State of Utah
DEPARTMENT OF NATURAL RESOURCES
DIVISION OF OIL, GAS AND MINING

RE: Draft Review, Reclamation As-Built, Castle Gate Mine, Amax Coal Company,
ACT/007/004-94E, Working File, Carbon County, Utah

Sowbelley Reclamation, Sbrd-1A ~ 0+15

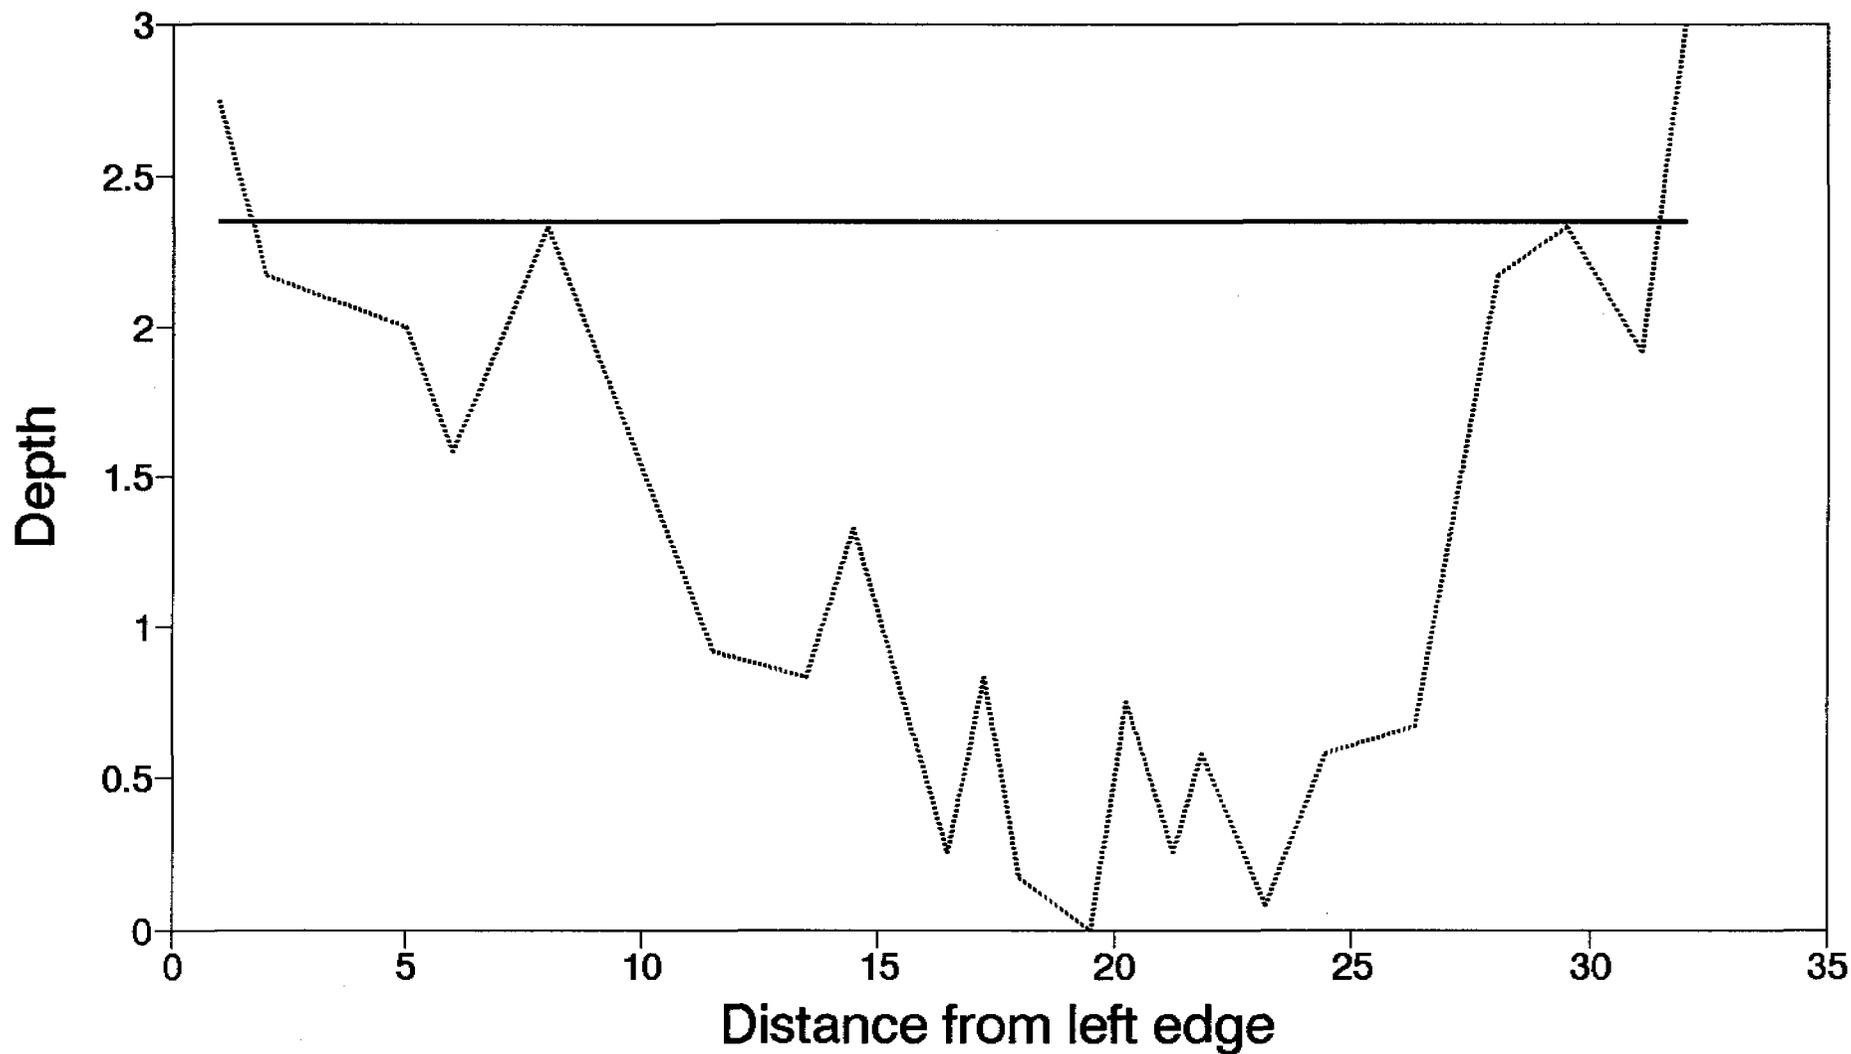
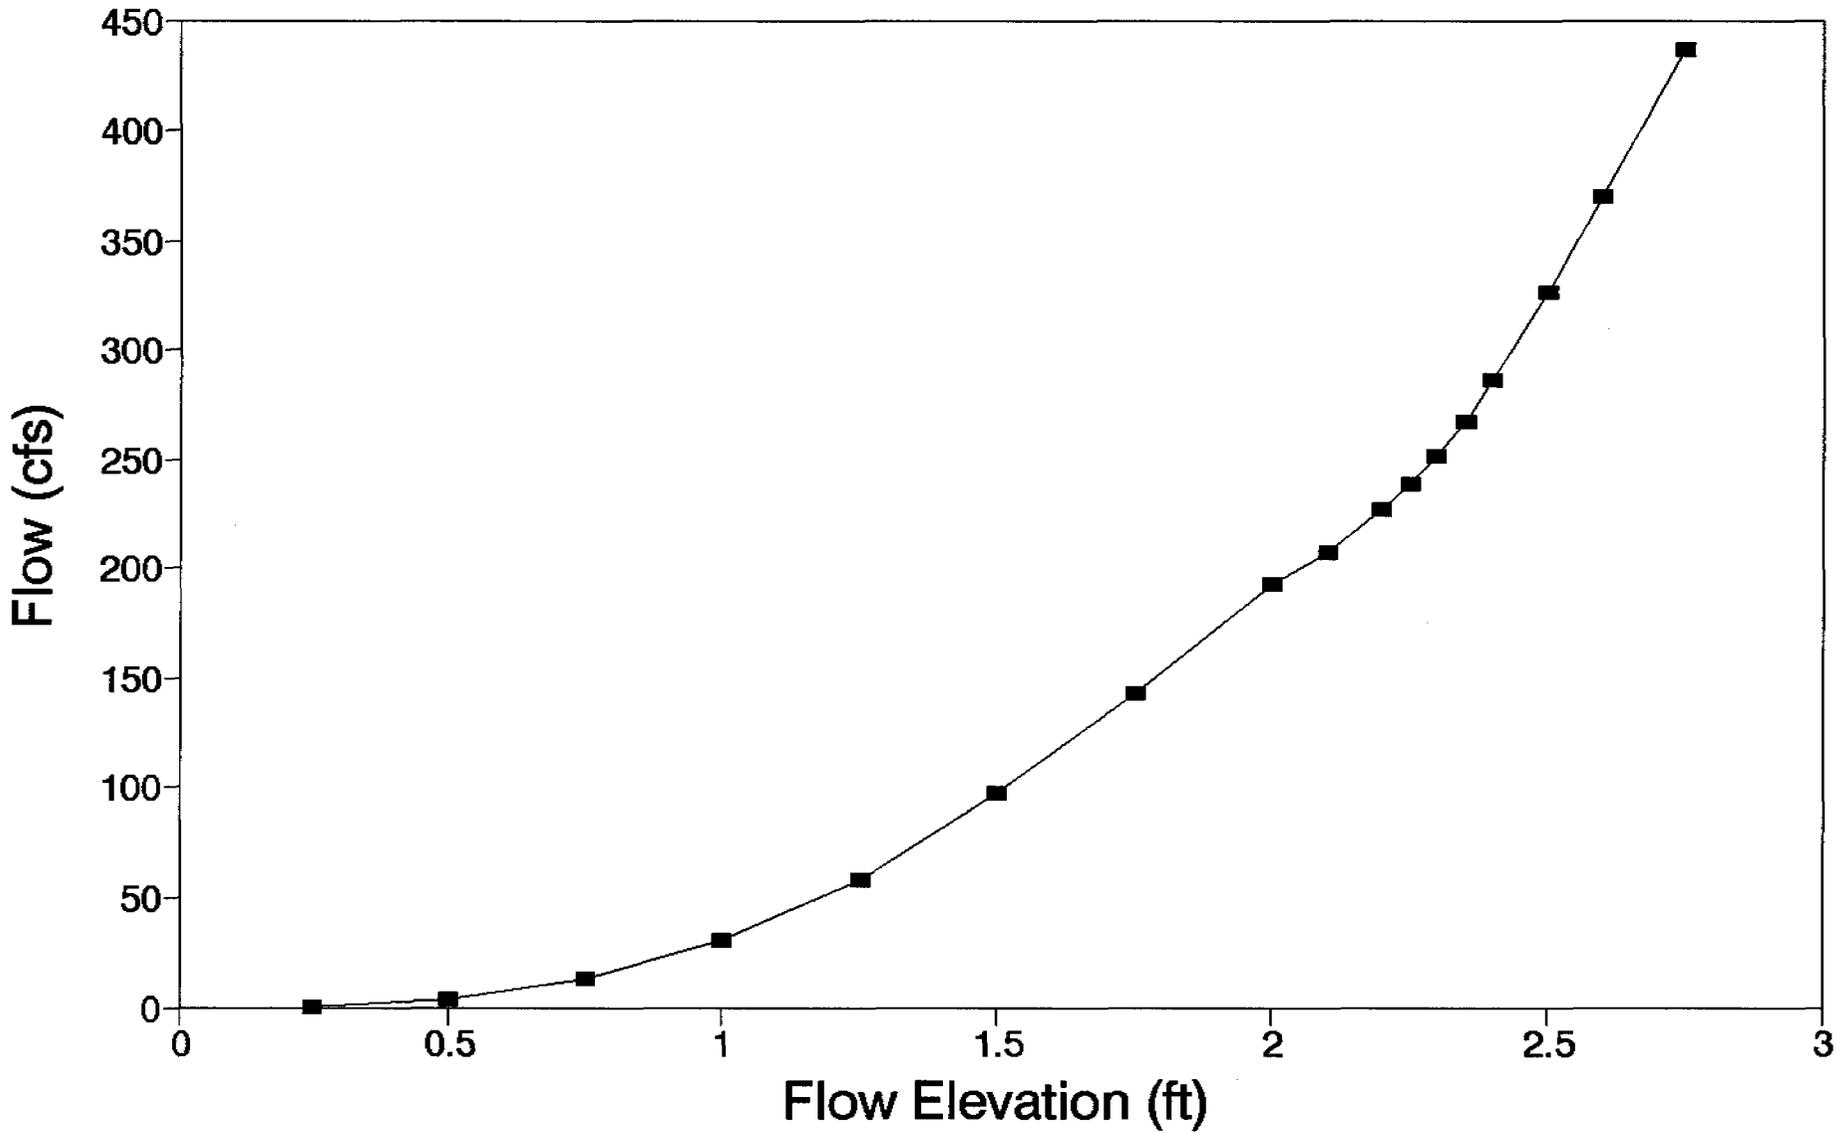
The freeboard on SBRD-1A, 1B, 1C, 1D, 9, and 10 all have less than 1.0-feet of freeboard. 1B, 1C, 1D, and 9 are less than 0.5-feet. Three of which are less than an 0.1-feet. These channels will be remeasured to see if they are as marginal as originally thought. Field measurements show that some areas are not adequate to convey the volume for the design storms.

1. All diversions must included, at minimum, 6-inches of freeboard above the size requirements which pass the design (100-year, 24-hour) storm event. Areas that do not have adequate flow depth to contain the 100-year, 24-hour storm runoff will need to be modified or reconstructed to the original design size.

Sowbelley Reclamation, Sbrd-1C ~ 5+00

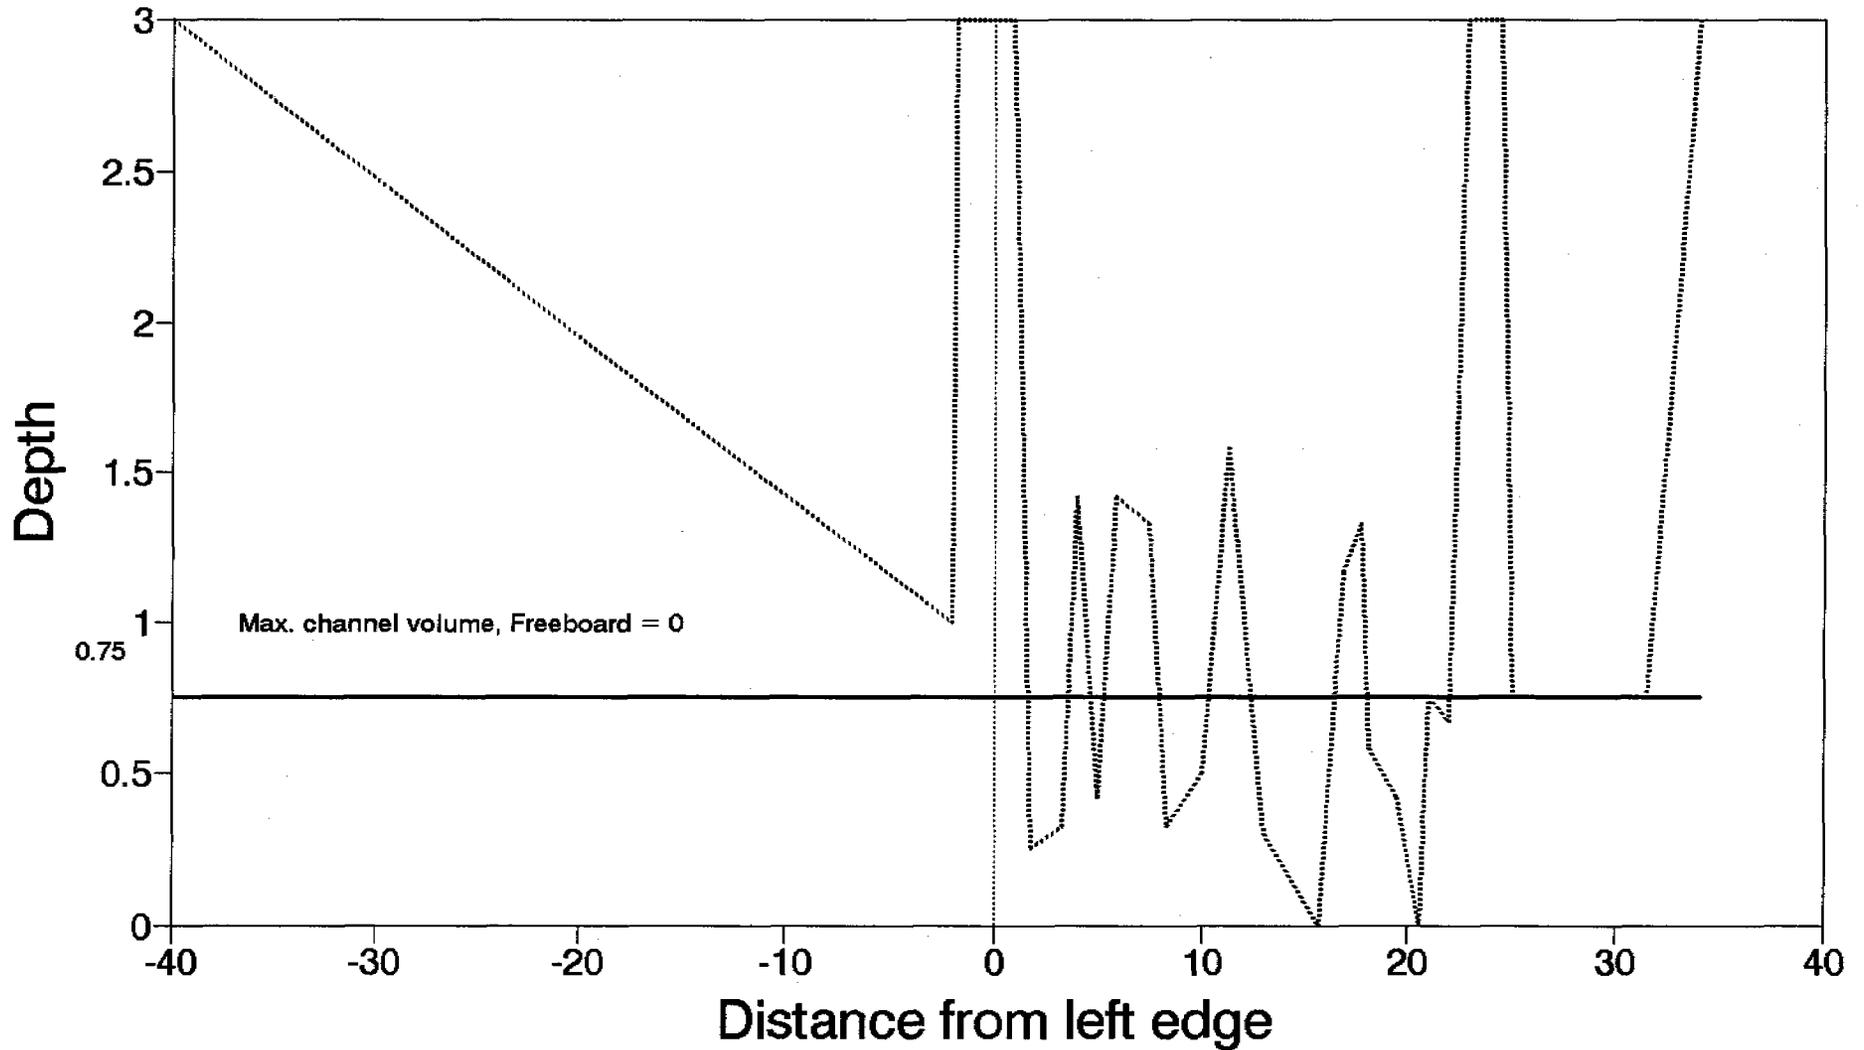
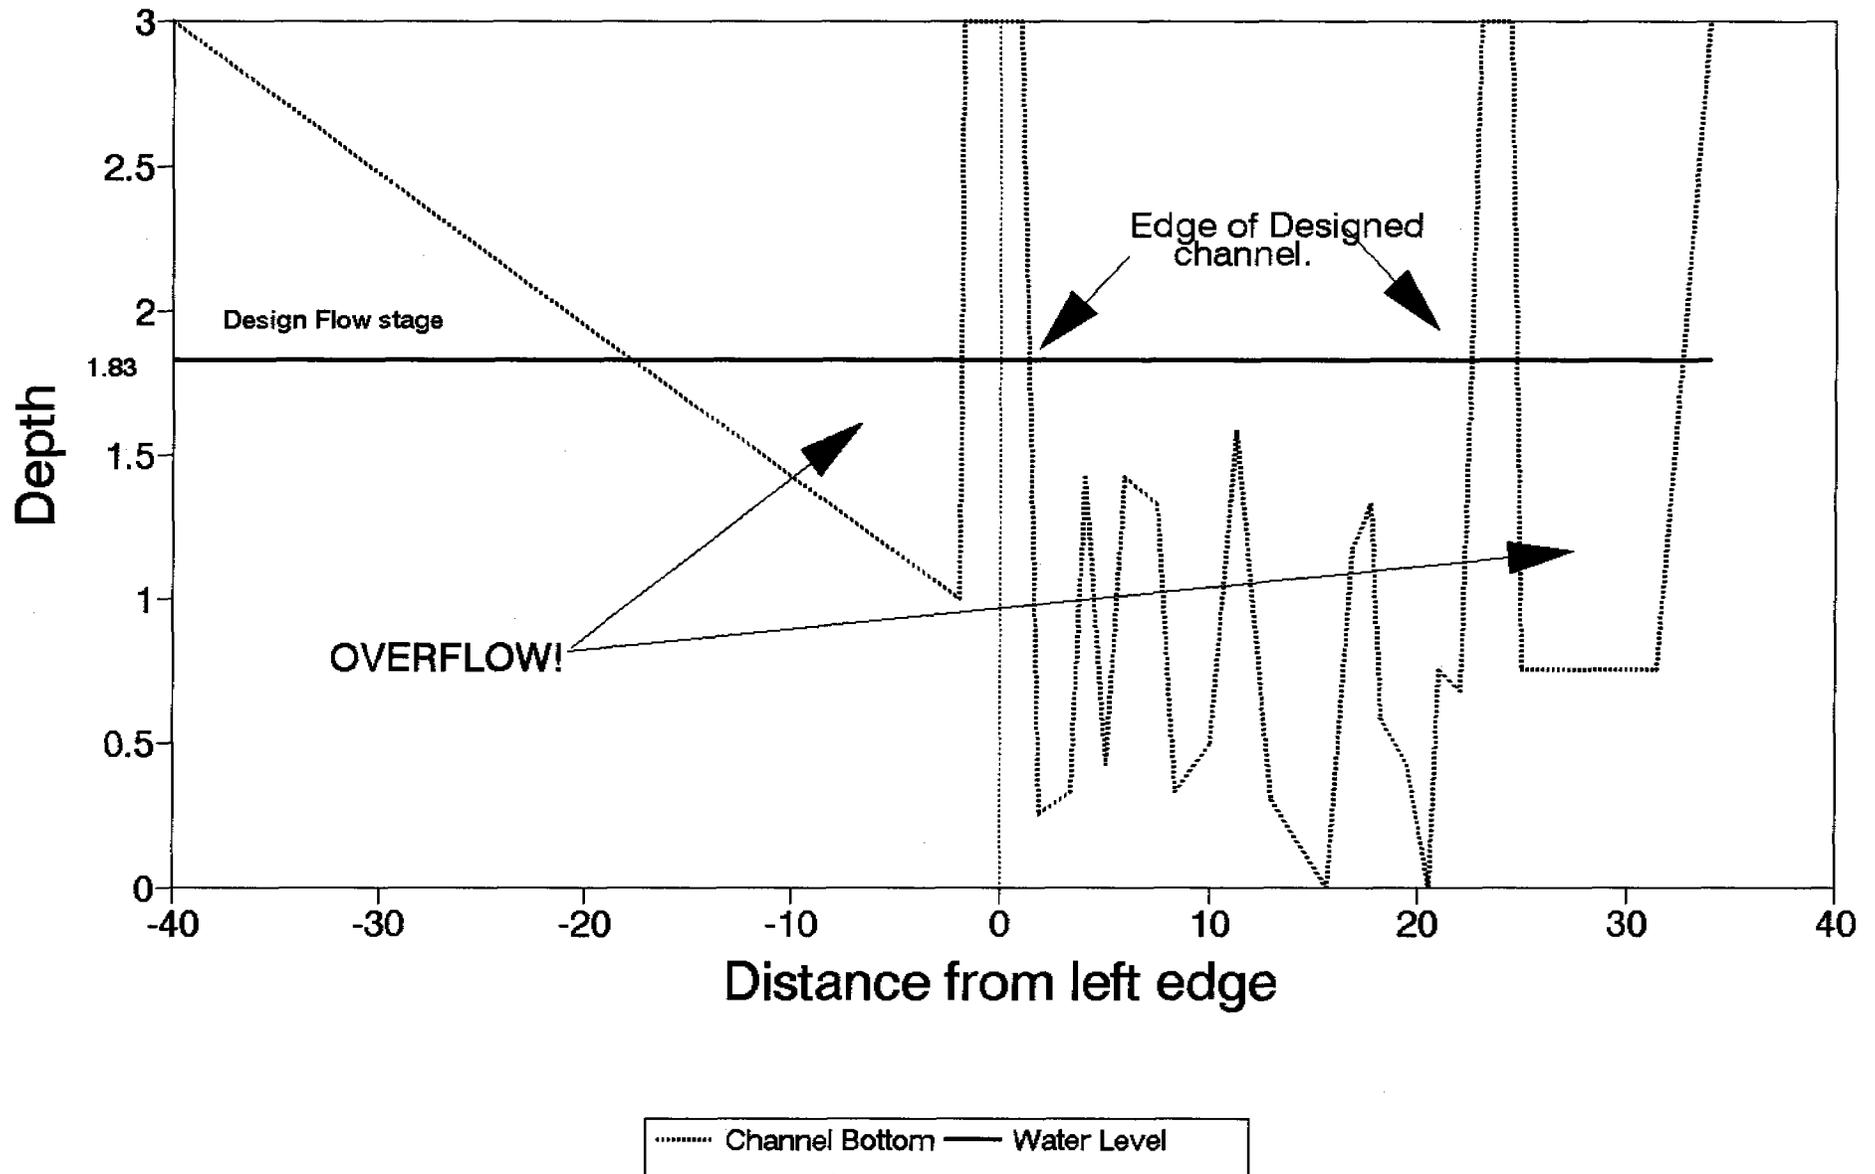
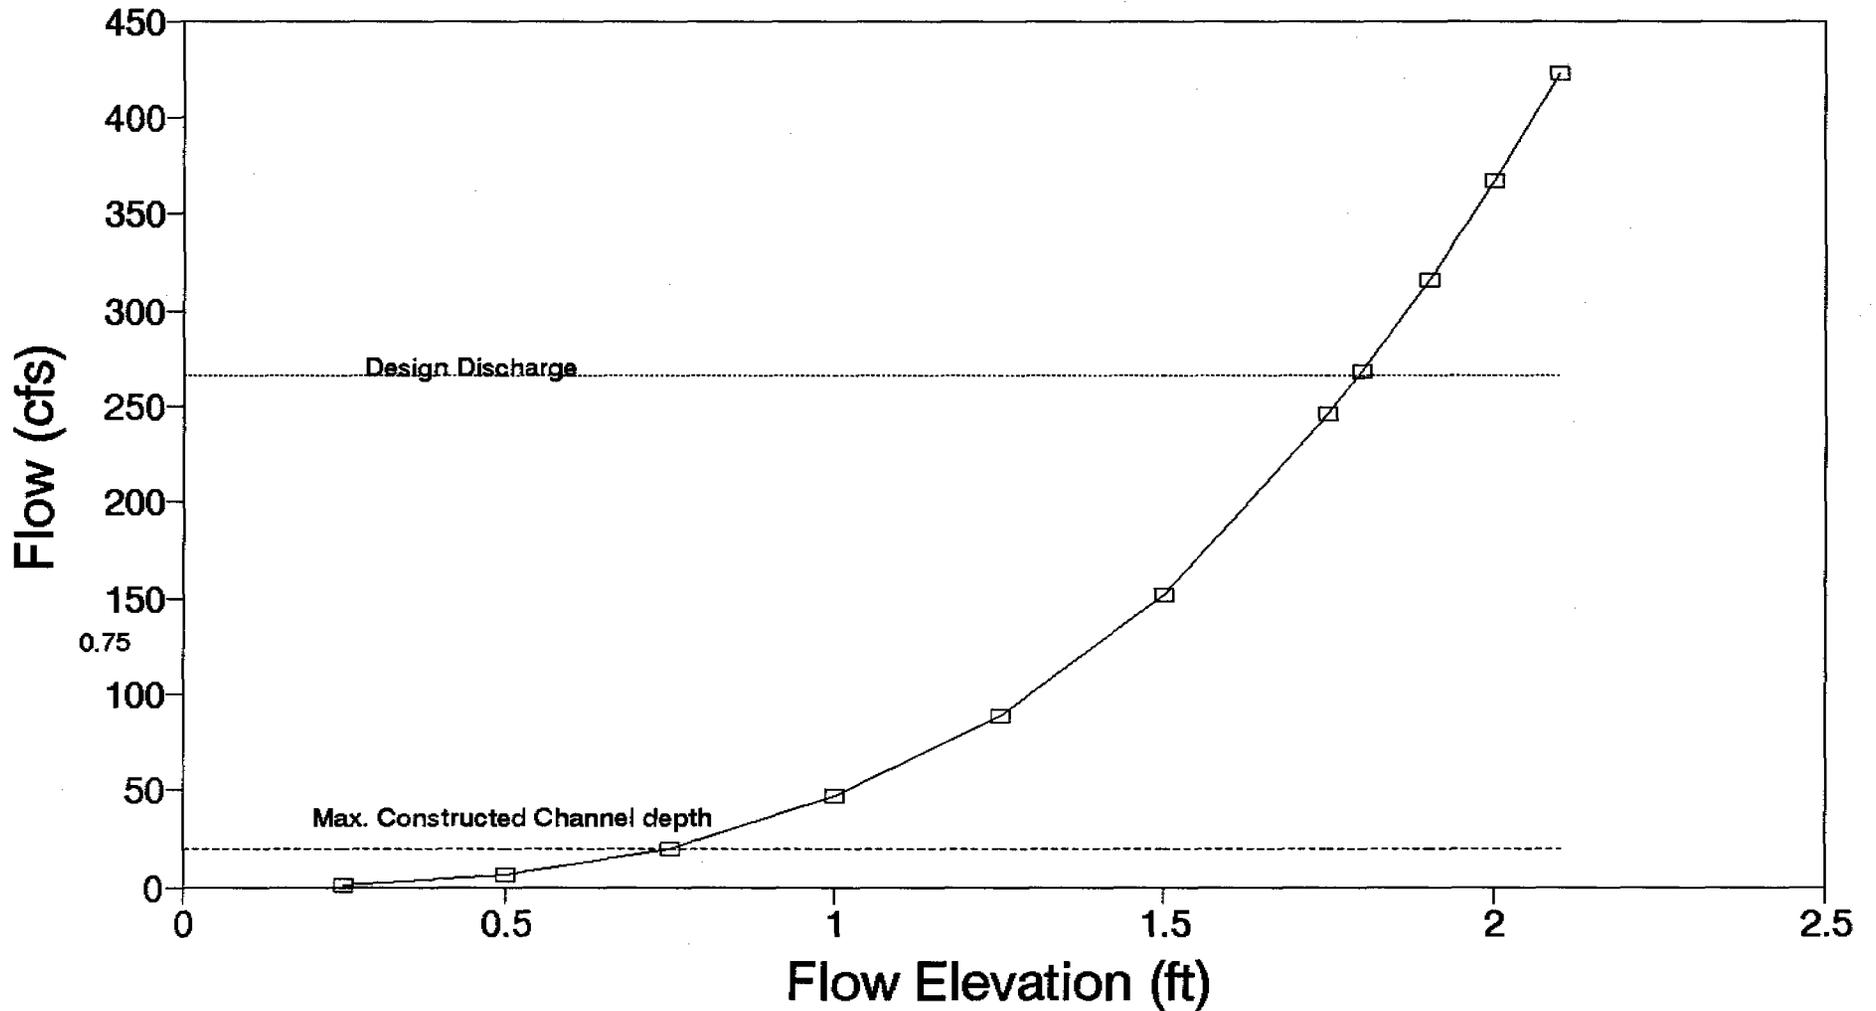
Field measurements made by the Division show that some areas are not adequate to convey the volume for the design storms. It appears that riprap was place on areas that were to shallow to begin. Then after the riprap was place the effective flow area was diminished even more. See the attached figures (Cross Sections and Rating Curves for SBRD-1C.) Areas where flow depth is not adequate will require reconstruction.
